BELLEFONTE NUCLEAR PLANT (BLN) - NATIONAL POLLUTANT DISCHARGE  
ELIMINATION SYSTEM (NPDES) PERMIT NO. AL0024635 - PROPOSED PERMIT  
MODIFICATIONS

PROPOSED CHANGES TO THE  
NATIONAL POLLUTANT DISCHARGE ELIMINATION SYSTEM (NPDES)  
PERMIT FOR BELLEFONTE NUCLEAR PLANT (BLN)

BELLEFONTE NUCLEAR  
PLANT DISCHARGES  
NPDES PERMIT  
NO. AL0024635

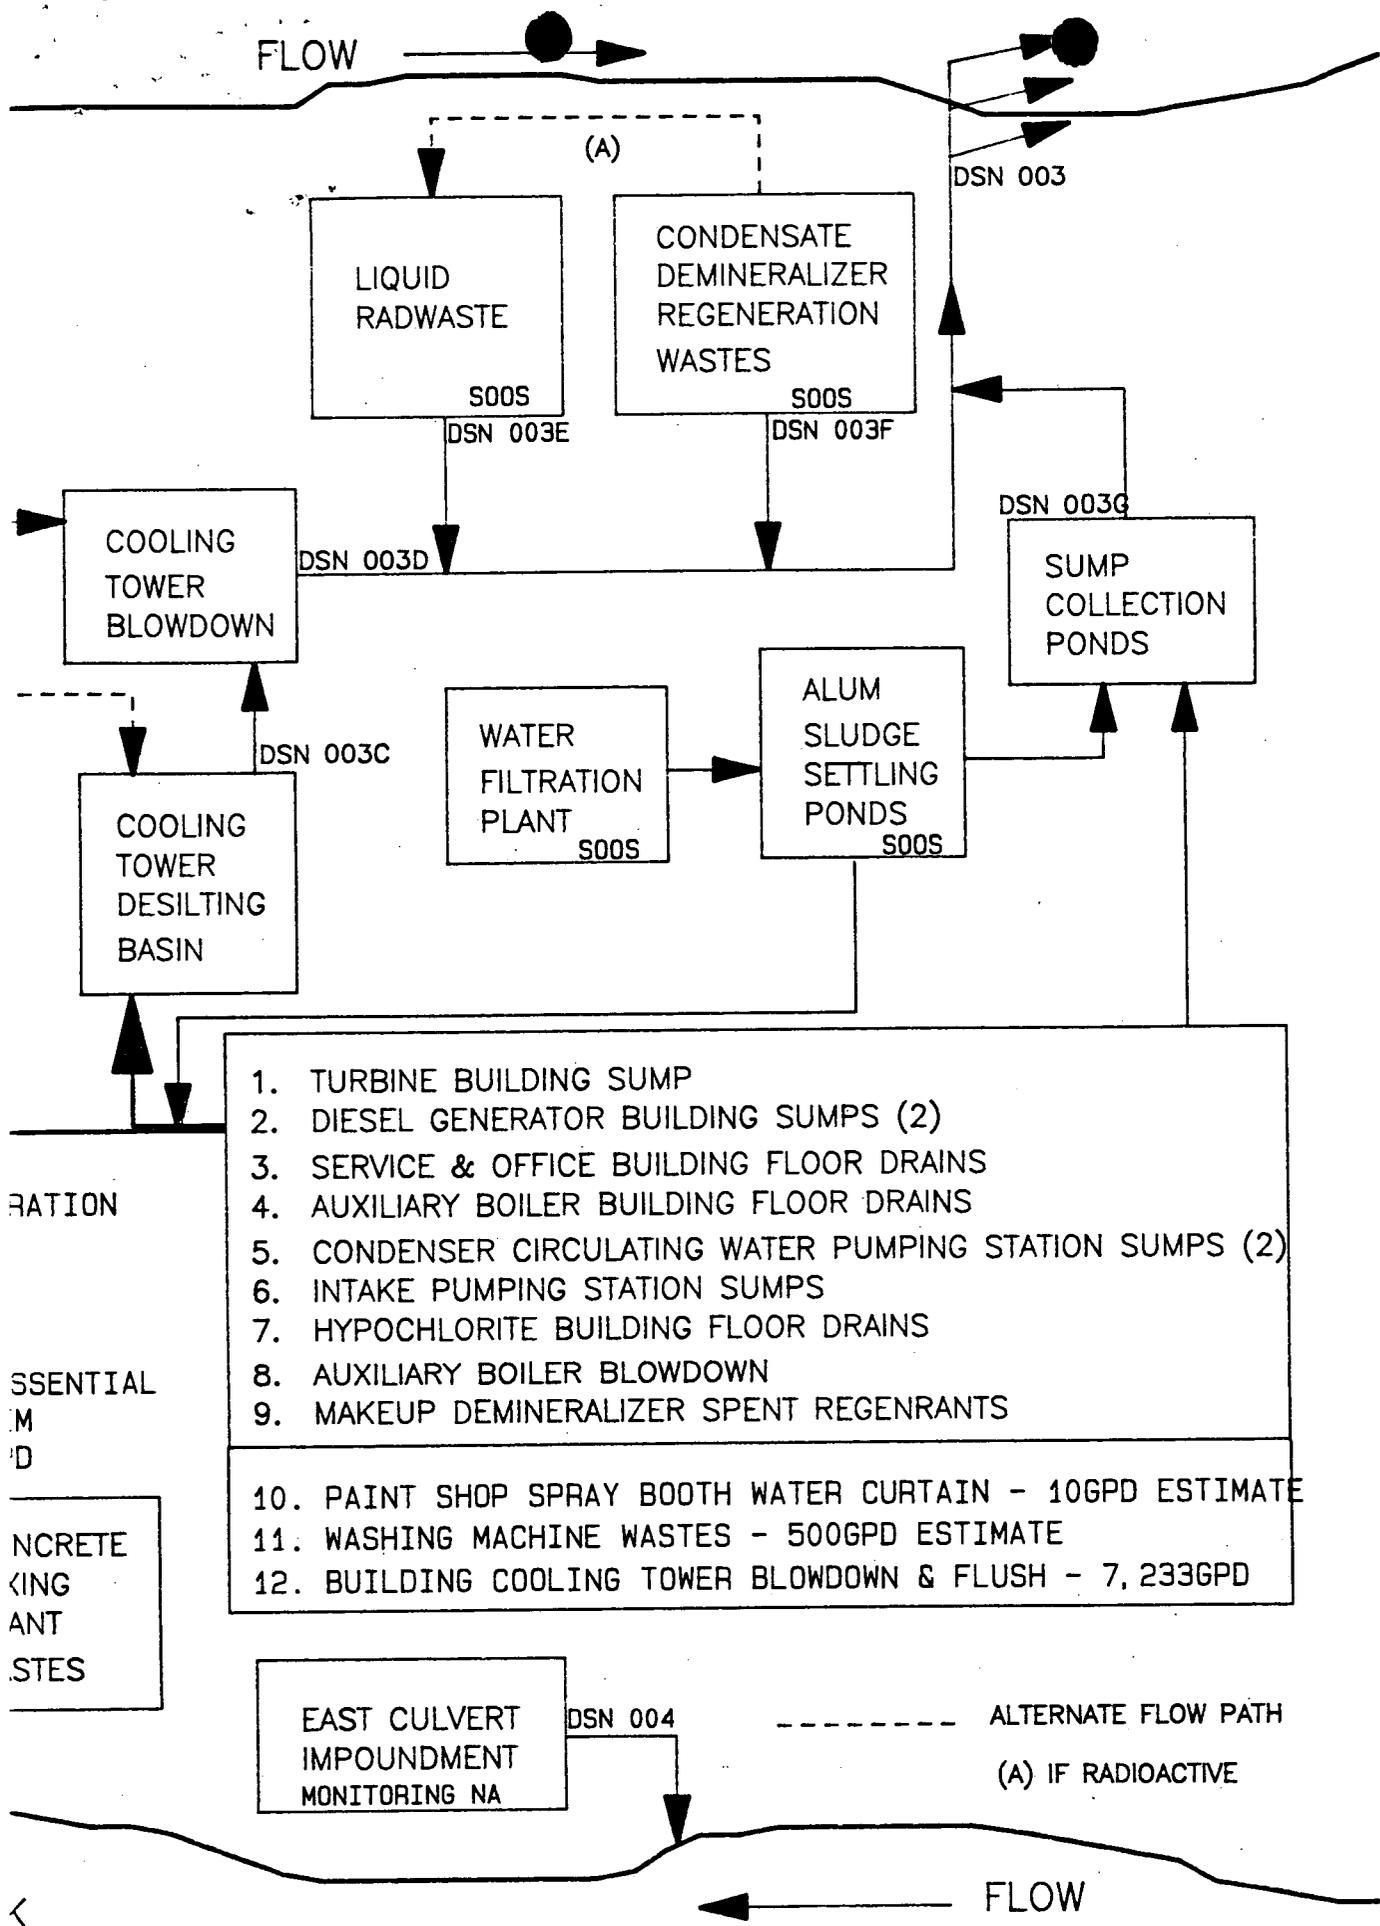
RED=PROPOSED  
MODIFICATIONS  
DURING DEFERRED  
CONSTRUCTION

BLUE=NEW  
WASTE SOURCES

- 10,714GPD 1. SURVEILLANCE TESTING/C OF DIESEL FIRE PUMPS
- 115GPD 2. DIESEL FUEL STORAGE SPILL CONFINEMENT AREA
- 3. EMERGENCY RELEASE OF RAW COOLING WATER SYS APPROXIMATELY 600,000

DSN 002A & NA  
DISCHARGE  
ELIMINATED  
DSN 002B

ALTERNATE FLOW PATH
